Vintage Denim Studio Ltd.(Extended Building)

MSSFB-2, EPZ, PAKSHI, ISHWARDI, PABNA
(24.089065, 89.033439)

2nd June 2021

Observations

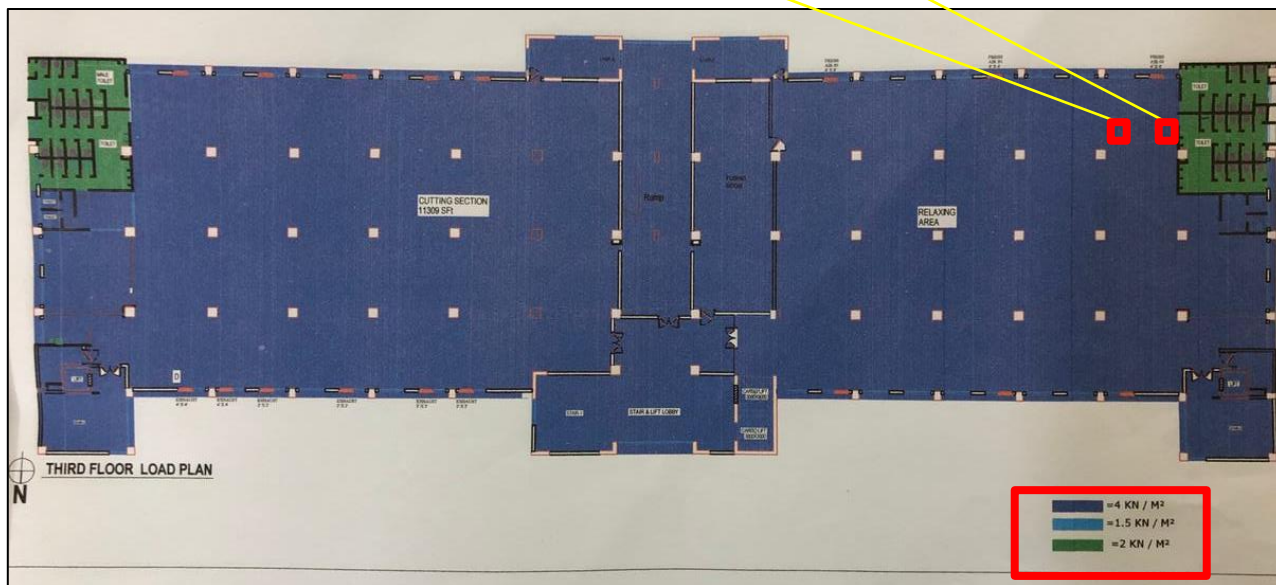
In general note of concrete, design strength has been considered 3500 psi but no concrete mixing ratio has been mentioned.

As per BNBC every building or structure designed shall have its design documents prepared in accordance with the provision of Section 1.9.1. The design document shall include a design report, and a set of structural drawings, which shall be prepared in compliance with section 1.9.1.1 and section 1.9.1.2 as per BNBC. During the inspection, the design report was not found which is required to be prepared in compliance with section 1.9.1 (part-6, BNBC).

Uncontrolled loading at 3rd Floor

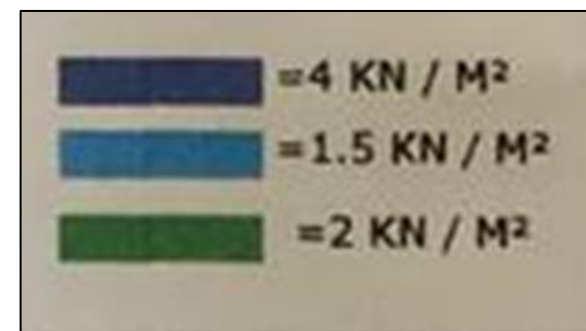
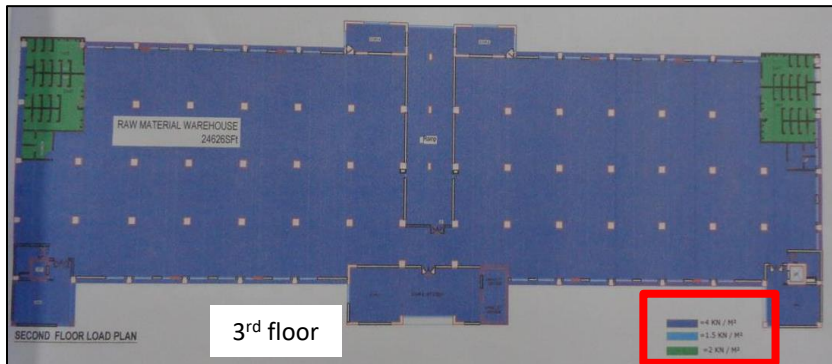
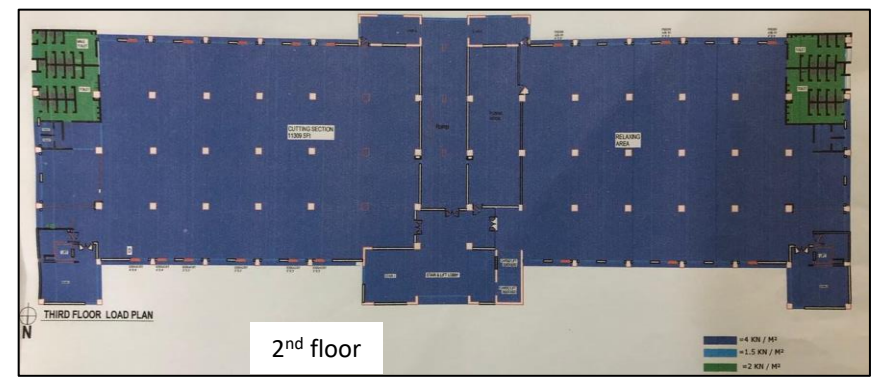
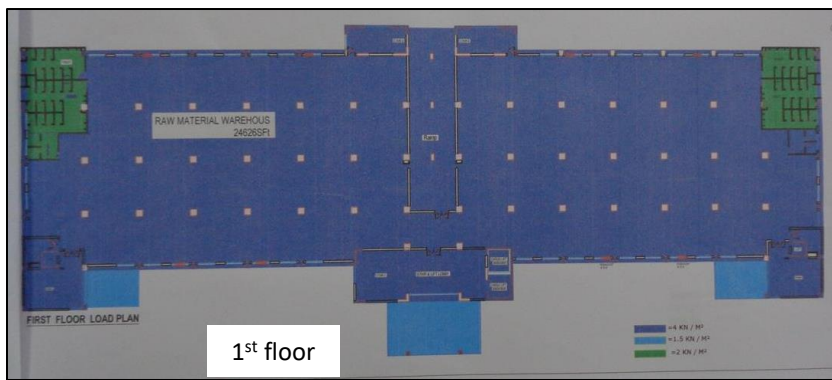
Uncontrolled loading was found on 3rd floor of the building due to stack of the denim roll. Loading was found more than 4 kPa. Factory is required to maintain the floor live load within 4 kPa as per prepared live load plan.

Factory is required to maintain the floor live load within 4 kPa as per prepared live load plan. Also provide the load limit marking or notice at storage area.

Cracks in brick wall

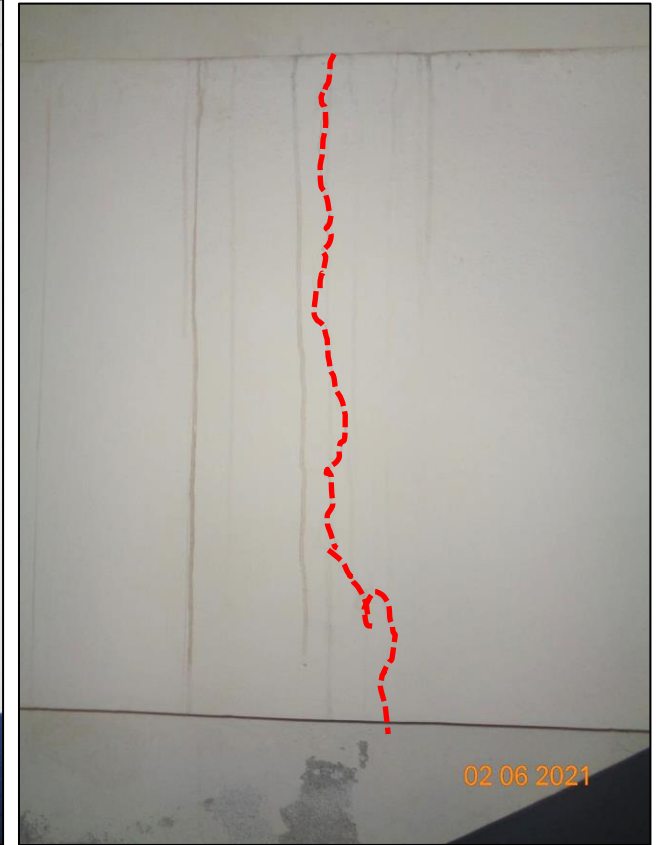
Severe crack was found in brick wall at 3rd floor toilet zone area. Also, cracks were found at façade wall. These cracks may have been generated due to the torsional irregularity of the structure or/and deflection of slab.

Factory engineer is required to investigate the cause of crack and repair the crack as per recommendation from investigation report.

**Leakage in water supply line and signage of water
ponding at roof**

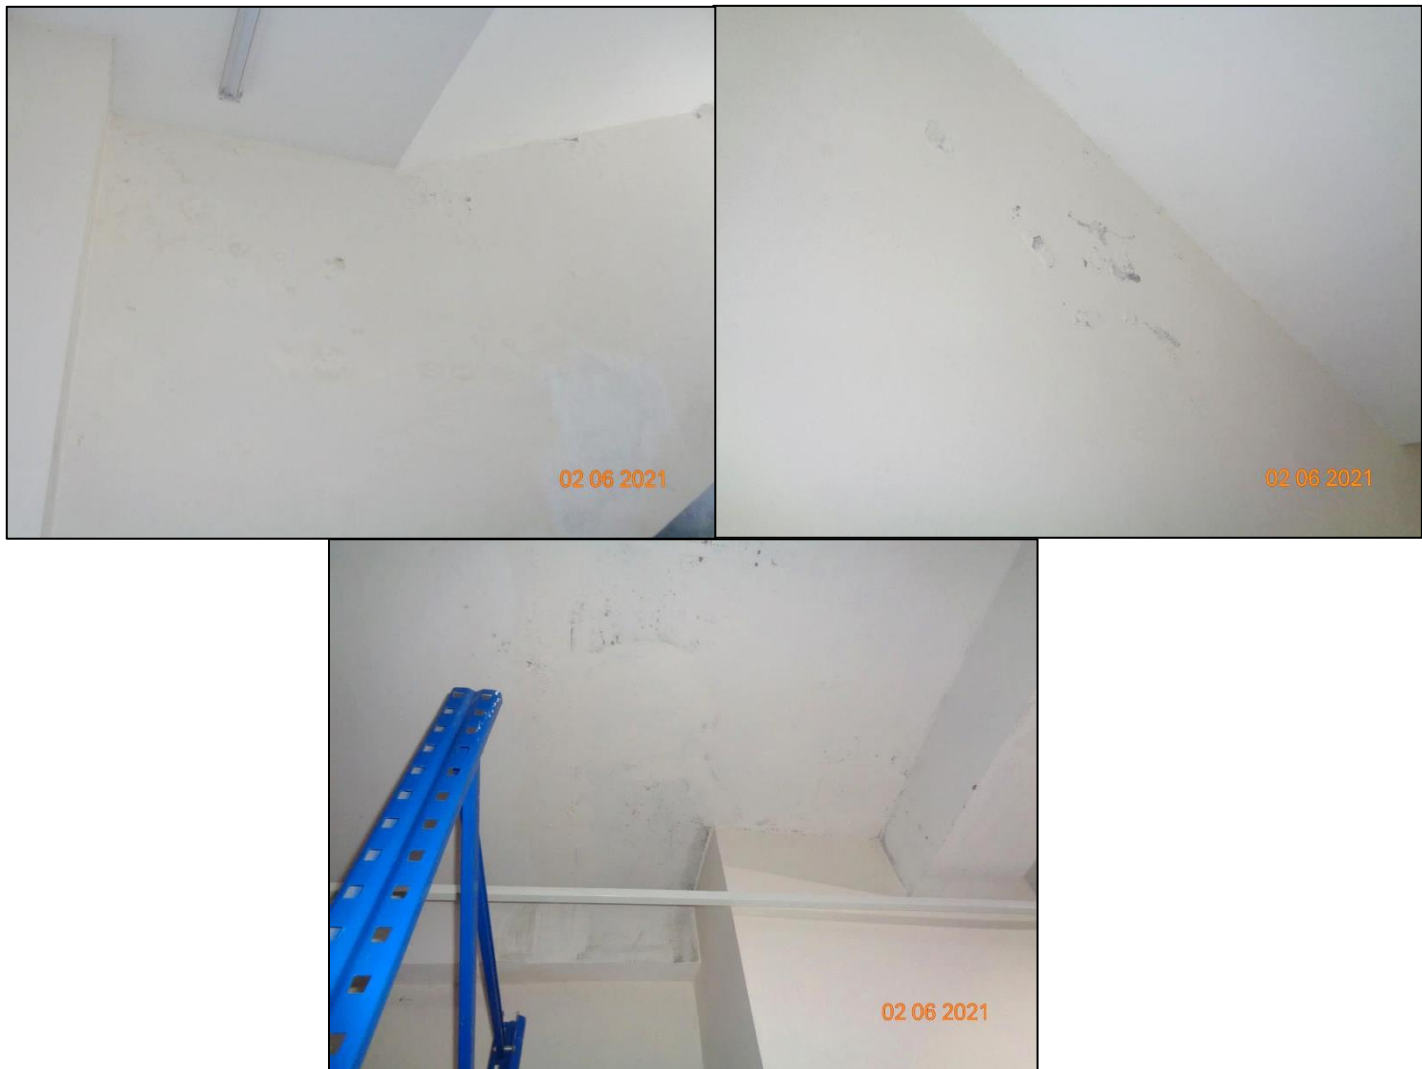
Due to leakage in the water supply line water ponding found at roof. Also, signage of water ponding found at roof due to depression in water proofing layer.

Factory engineer is required to take necessary measures to repair the leakage in the water supply line and improve the drainage system to prevent the water ponding at roof.

Lack of lateral stability

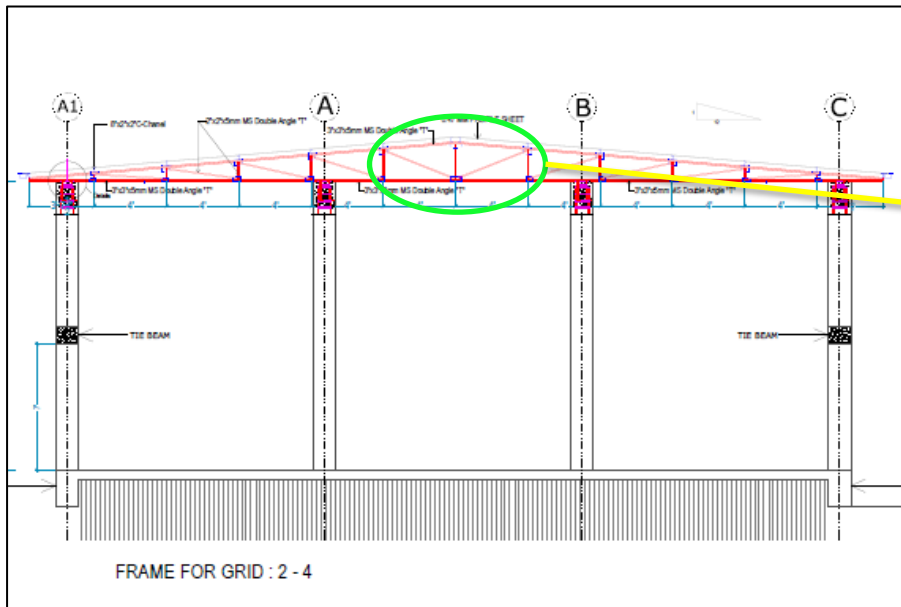
The steel roof truss is supported by RC column. There is no vertical & roof bracing was found. As a result, there is no apparent load path to transfer the lateral loading along the long direction. Building Engineer is required to check the lateral stability of the steel shed and check the adequacy of the connection.

As per BNBC every building or structure designed shall have its design documents prepared in accordance with the provision of Section 1.9.1. The design document shall include a design report, and a set of structural drawings, which shall be prepared in compliance with section 1.9.1.1 and section 1.9.1.2 as per BNBC. During the inspection, the as built drawings & design report has not been found. Now, the building engineer is required to prepare Engineering Assessment (EA) for the structure. which compliance with section 1.9.1 (part-6, BNBC).

Orientation of truss diagonal members

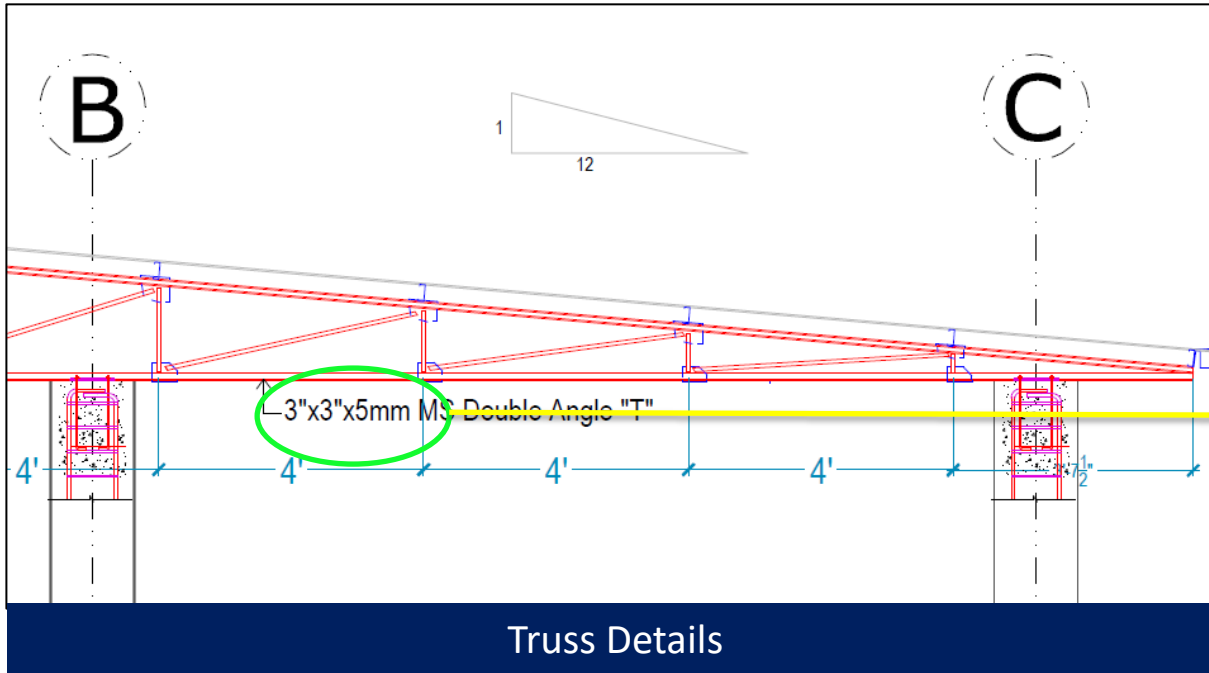
Orientation of truss diagonal members were found different from as-built drawing. Building Engineer is required to survey the whole structure and prepare accurate as-built (both architectural & structural) drawings.

Measurement of truss bottom angle thickness

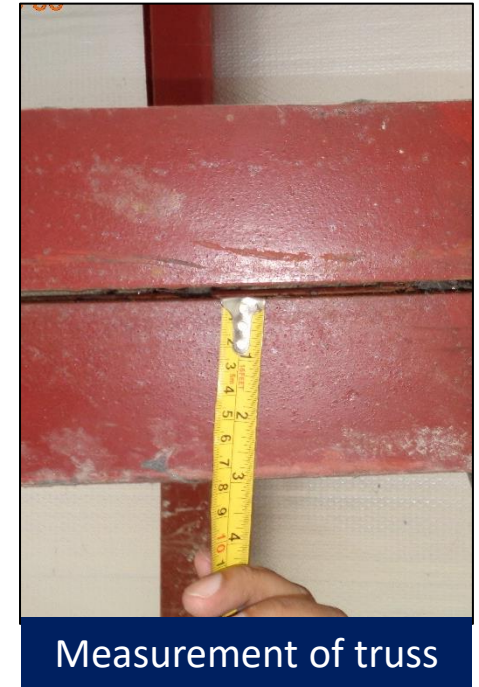
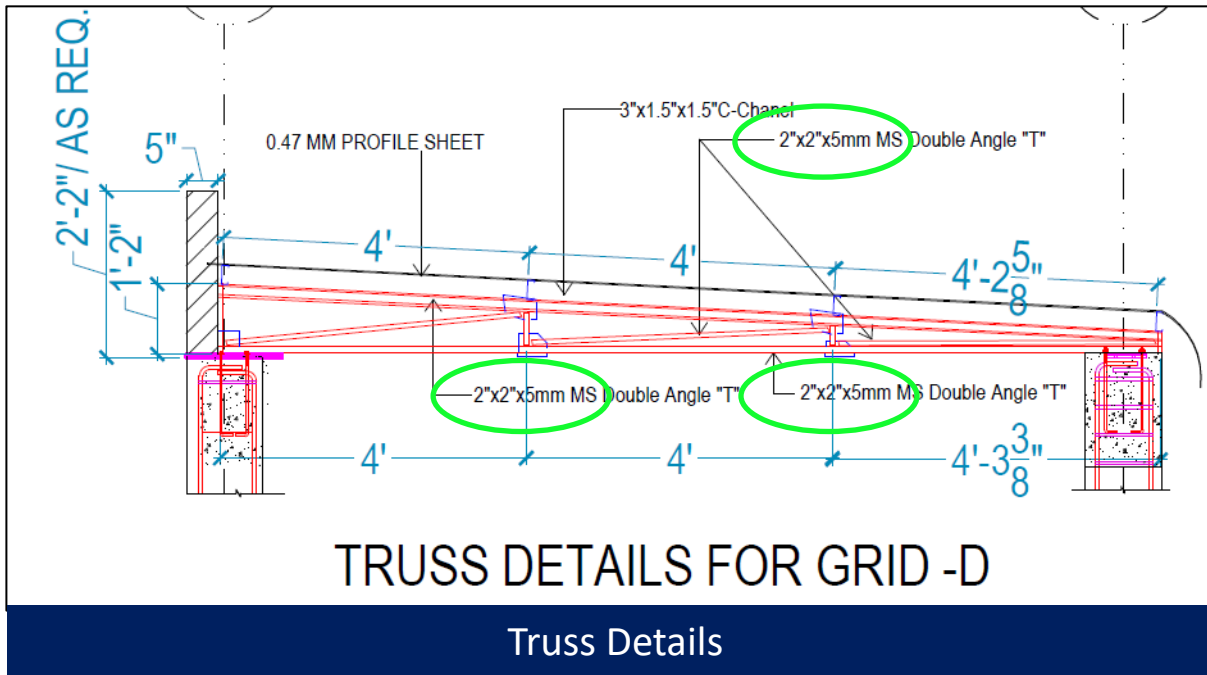
Truss bottom angle thickness was measured 4.5 mm but in as-built drawing it was found 5 mm. Building Engineer is required to survey the whole structure and prepare accurate as-built (both architectural & structural) drawings.

Orientation of truss diagonal members

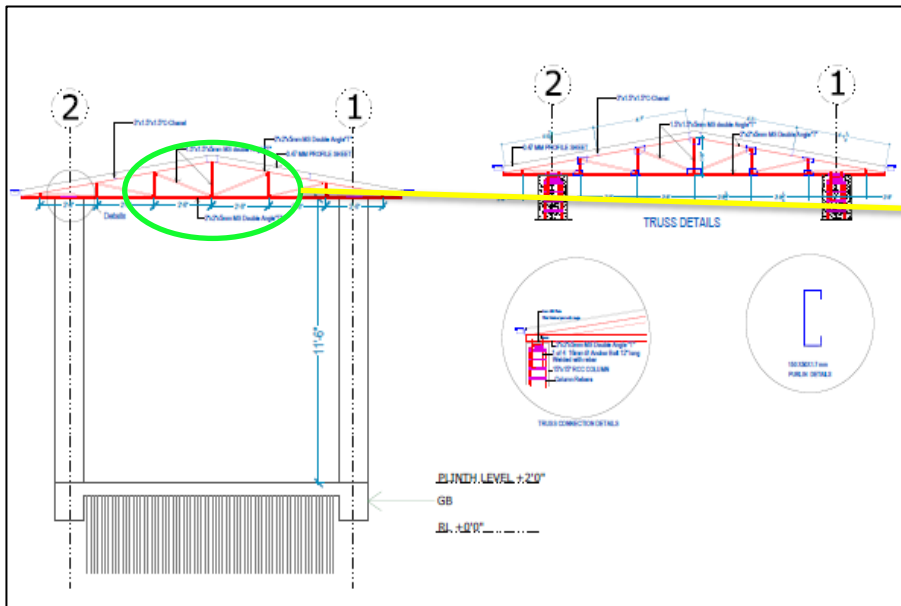
Orientation of truss diagonal members were found mismatch with as-built drawing. Building Engineer is required to survey the whole structure and prepare accurate as-built (both architectural & structural) drawings.
